SUBJECT: Submits addl info re human factors under appeal, per NRC mgt 830224-25 site visit. Current configuration of control board 206 will not pose increased risk to health & safety nor involve unreviewed safety question.

March 11, 1983
L-83-145

Re: St. Lucie Unit No. 2
Docket No. 50-389
HFEB AUDIT FINDINGS
A.8.7 & A.8.9

FIGURE 1.

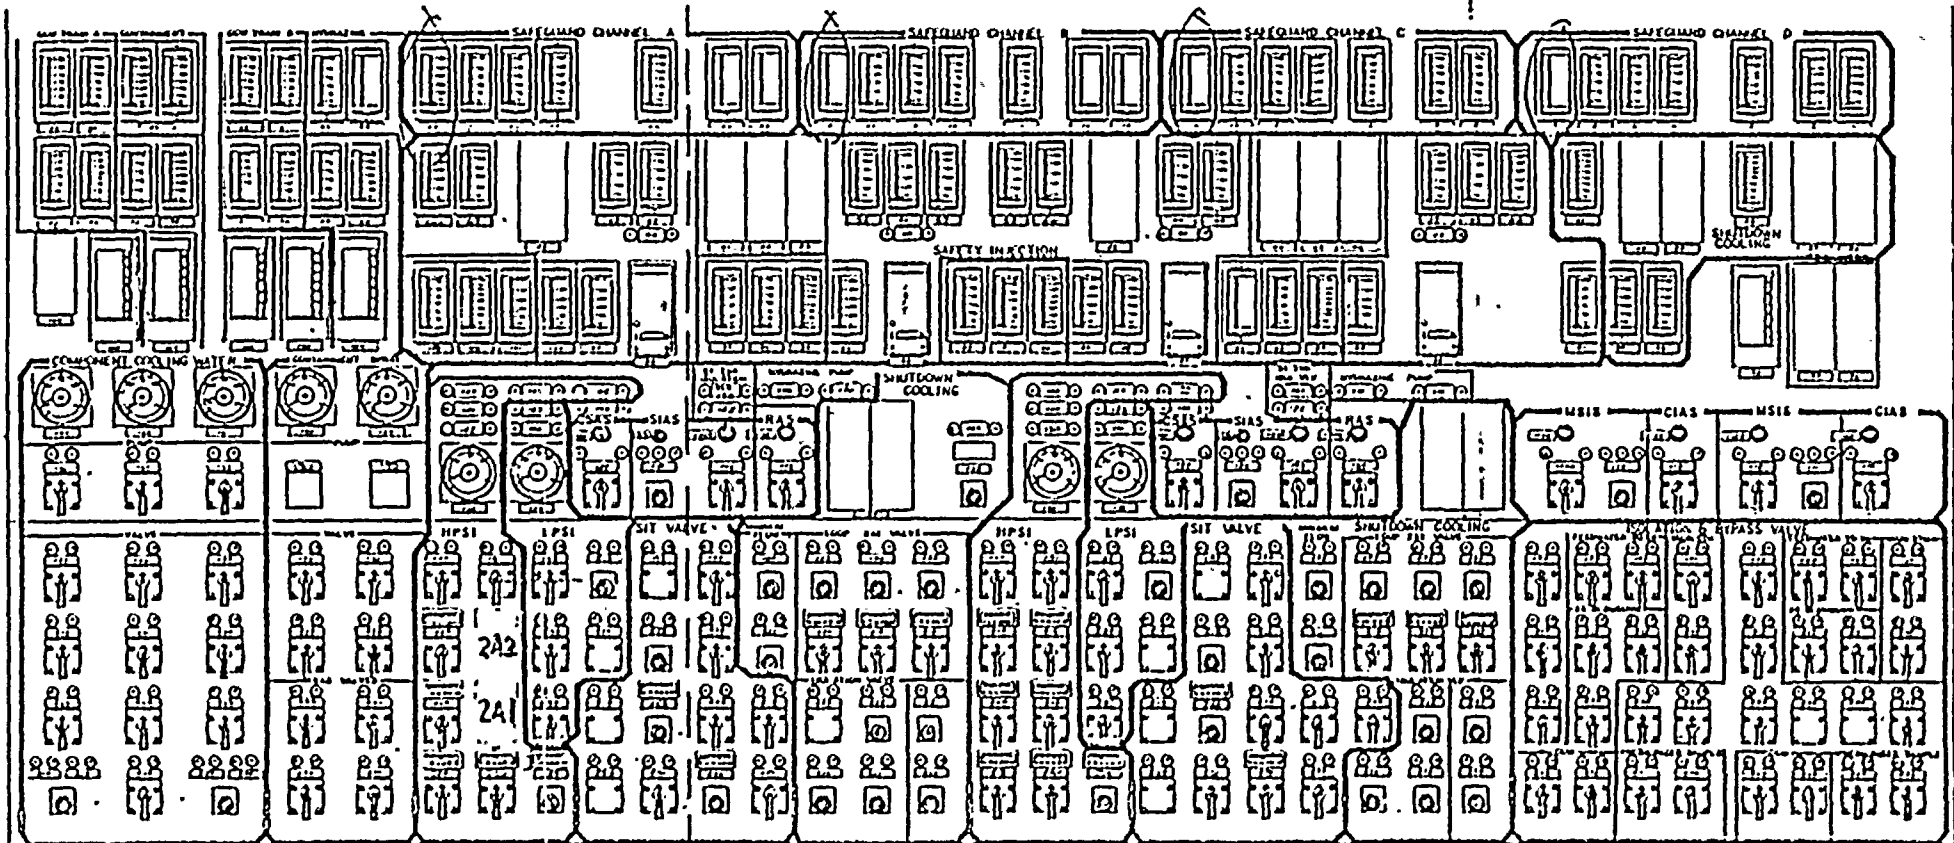
Of the equipment identified to be reworked (Attachment 2), eight displays, two hand controllers, eight hand switches and 12 indicating lights are associated with safety injection tanks 2A1 and 2A2. (See Item 1 on Figure 1).

Of the equipment identified to be reworked (Attachment 2), two displays, two hand switches, and four indicating lights are associated with the low pressure injection supply to cold leg loops 2A1 and 2A2 (See Item 2, Figure 1). Low pressure injection is activated upon receiving an automatic safety injection activation signal. No operator intervention is required unless any of the equipment fails to align properly or a header break is indicated.

The task analysis postulated manual corrections by the operator in case of a ruptured header. In addition, in this scenario, the operator also selected to isolate the wrong header. The valves associated with the controls take between 10 and 15 seconds to stroke from full open to full close. They are also alarmed and annunciate if their safety injection position is overridden, thus providing the operator with: 1) a display indicating flow; 2) valve status lights indicating valve position; 3) valve position indicator (percent open) and; 4) valve safety injection signal actuation override annunciation. When the operator isolates the wrong header, operator error would be identified in less than 20 seconds when the ruptured header flow does not decrease and the header high flow alarm remains illuminated,

at which time the operator would correct the valve lineup by opening the isolated header valve and closing the correct header isolation valve. The total response time from the instant the error is made to the time the system is restored to proper alignment is expected to be less than 60 seconds. Florida Power & Light Company feels that there is no increased safety risk or reduction in operator performance if the subject displays, hand switches and indicating lights are not modified to conform to a left-to-right and top-to-bottom ascending order.

Of the remaining equipment to be reworked (Attachment #1), two displays are associated with the high pressure injection supply to Cold leg loops 2A1 and 2A2 (See Item 3, Figure 1). High pressure injection is activated upon receiving an automatic safety injection activation signal. No operator intervention is required unless any of the equipment fails to align properly or a cold leg header break is indicated.

The task analysis postulated manual corrections by the operator in case of a ruptured header. In addition, in this scenario, the operator also selected to isolate the wrong header.

The valves associated with these controls take 10 seconds to stroke from full open to full close. They are also alarmed and annunciate if their safety injection position is overridden thus providing the operator with: 1) a display indicating flow; 2) valve status lights indicating valve position; 3) valve position indicator (percent open); and 4) valve safety injection signal actuation override annunciation. Should the operator isolate the wrong header, the operator error would be identified in less than 20 seconds when the ruptured header flow does not decrease and the header high flow alarm remains illuminated at which time the operator would correct the valve lineup by opening the isolated header valve and closing the correct header isolation valve. The total response time from the instant the error is made to the time the system is restored to proper alignment is expected to be less than 60 seconds. Florida Power & Light Company feels that there is no increased safety risk or reduction in operator performance if the subject displays are not modified to conform to a left-to-right ascending order.

Florida Power & Light Company has demonstrated that the current configuration of Control Board #206 will not pose an increased risk to the health and safety of the public, nor does it involve an unreviewed safety question which would warrant rework of the control board prior to core load.
